1 Products affected

2 Type of change

Product Change Notification					PCN 6762 (snap-in)		
owner	creation date	release date	released by	change order no	rev	page	
huberth	25.09.2019	01.10.2019	limachcl	2018434	A	1 of 1	D10-039-976

3 Detailed description of change

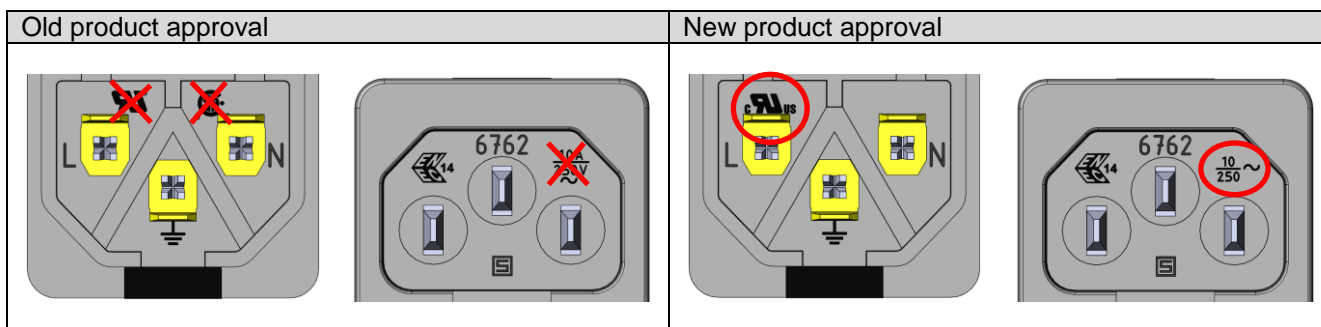
Change of approval markings from UR and CSA to the combined cURus on the product socket.

Form	Yes	Socket new with cURus approval marking
Fit	No	-
Function	No	-
Manufacturing	No	-
Label	No	-
Packaging	No	-
